COUNCIL ASSESSMENT REPORT

Panel Reference	2017HCC002
DA Number	DA/11/2017
LGA	Lake Macquarie City Council
Proposed Development	Demolition Works, Commercial Premises and Residential Flat Building
Street Address	5 Edgar Street, Belmont (Lot 10 Sec B DP 585) 7 Edgar Street, Belmont (Lot 11 Sec B DP 585) 9 Edgar Street, Belmont (Lot A DP 400644,) 11 Edgar Street, Belmont (Lot B DP 400644) 2 Sharp Street, Belmont (Lot 6 DP 12898) 4 Sharp Street, Belmont (Lot 5 DP 12898) 6 Sharp Street, Belmont (Lot 4 DP 12898) 8 Sharp Street, Belmont (Lot 1 DP 353066) 10 Sharp Street, Belmont (Lot 2 DP 353066) 32 Brooks Parade, Belmont (Lot 3 Sec B DP 585) 36 Brooks Parade, Belmont (Lot 4 Sec B DP 585) 38 Brooks Parade, Belmont (Lot A DP 339105) 40 Brooks Parade, Belmont (Lot B DP 339105) 42 Brooks Parade, Belmont (Lot 8 DP 12898)
Applicant	Monteath and Powys Pty Ltd
Owner	Allbeach Pty Limited AM, KL and MF Brown BSE Holdings Pty Limited Lakesharp Developments Pty Limited Robert Neil McDonald

Report prepared by	Brian Gibson, Senior Development Planner, Lake Macquarie City Council
Report date	9 November 2017

Figure 9: Cross section of built form for the Block plan in the Belmont Town Centre

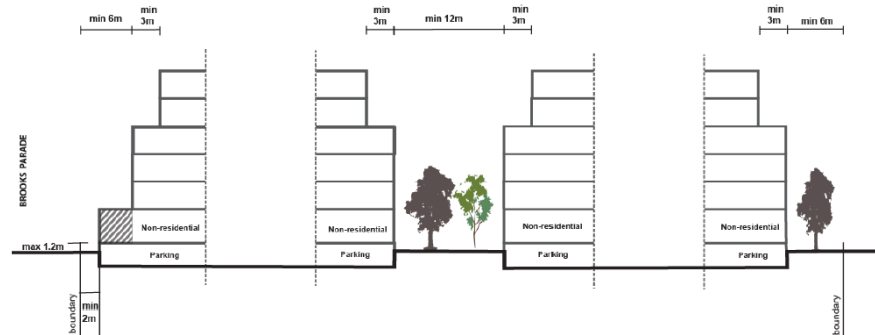
From the front property boundaries a setback of 2m applies to the basement car park/podium and a maximum 50% of the non-residential level off Brooks Parade, 6m to the car park/podium and non-residential level off Sharp and Edgar Streets and levels 2-4 above (residential), and 9m to levels 5-6 (residential). Setbacks from the common boundary with other lots as per the above diagram must meet the ADG requirements, ie. 6m setback for non-residential and residential levels up to the fourth level, and 9m setback for levels five and six.

Figure 10: Setbacks applying to 44 Brooks Parade

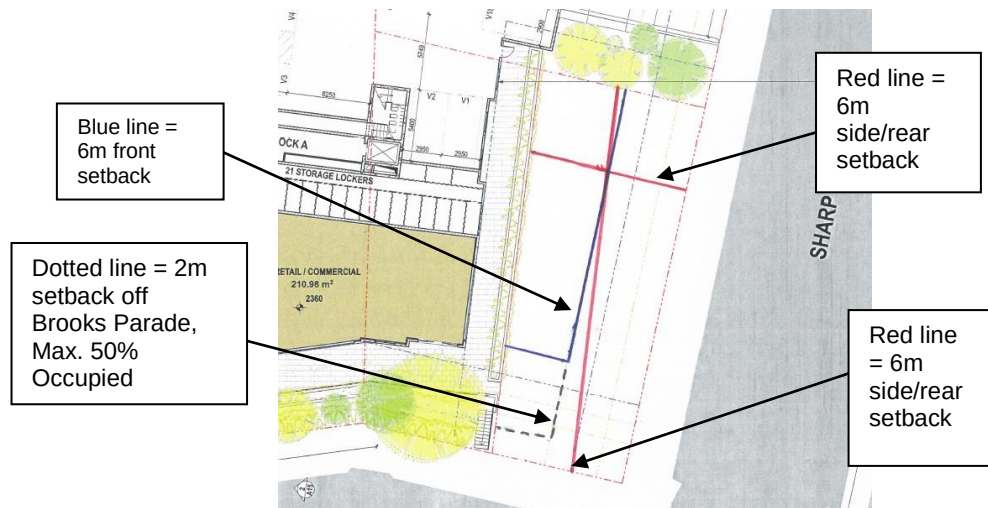
In considering the above setbacks, it must be noted 44 Brooks Parade has a varying east-west width of 10.06 to 12.65m. Therefore any development outcome on the lot would not be compliant with the required setbacks as indicated below in Figure 10.

Comment: As identified above under the objectives for the isolated lot controls, development of the amalgamated lots as proposed would result in 44 Brooks Parade being unviable for redevelopment to the scale and intensity as identified in the Belmont Town Centre Area Plan. Any development of the lot is restricted both by the lot width and area once the required setbacks are applied as shown in Figure 10.

Comment: The site has two frontages, one less than 20m. Additionally the it has a varying width of 10 to 12.5m. Consequently, development would not be able to achieve the maximum height limit of 22m (particularly as any redevelopment would require variations to setback controls under the DCP 2014 and ADG as shown in Figure 10).

Figure 11: Block C control plan – Belmont Town Centre Area Plan

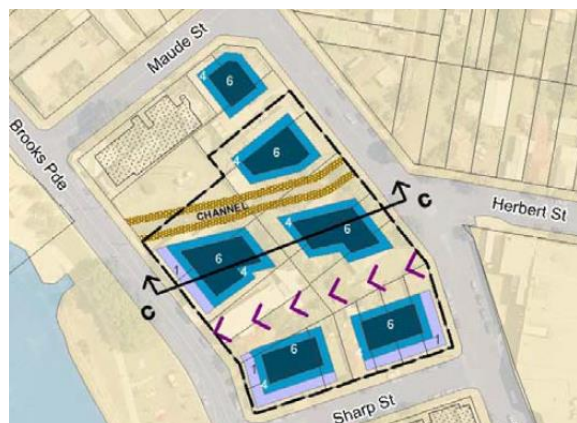
Comment: The block 'C' controls in DCP 2014 (Part 10.2 - Belmont) identify a built form at the corner of Brooks Parade and Sharp Street that necessitates the amalgamation of the development site and 44 Brooks Parade. The boundaries of the Block C control plan are shown in Figure 11 below.

The inclusion of this corner lot in the proposal is highly desirable and permits the successful resolution of street character, solar access and pedestrian movements and interactions between the public footpath

Figure 13: Easement to Drain Water Variable Width (DP 645060)

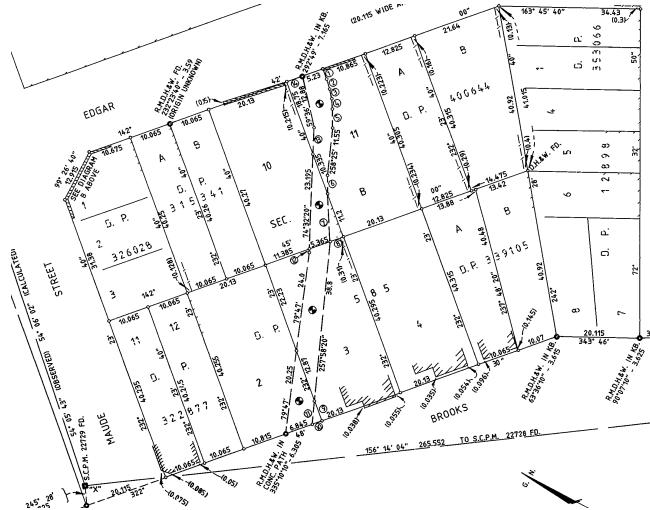
As stated above in Section 5 of this report, the development currently encroaches the easement with building overhangs and a pedestrian walkway.

Sub-clause (1) provides that any agreement, covenant or other similar instrument that restricts the carrying out of the development does not apply to the extent necessary to serve the purpose of enabling development. Sub-clause (2)(a) however states that sub-clause (1) does not apply to a covenant imposed by Council which is the case with regard to Deposited Plan 645060.

- g. Development is to be setback from the drainage channel for stability, compliance with Council's Policy for Building Over or Adjacent to a Drainage Easement and accommodate landscape planting in order to improve the canal elevation that is highly visible from Brooks Parade.
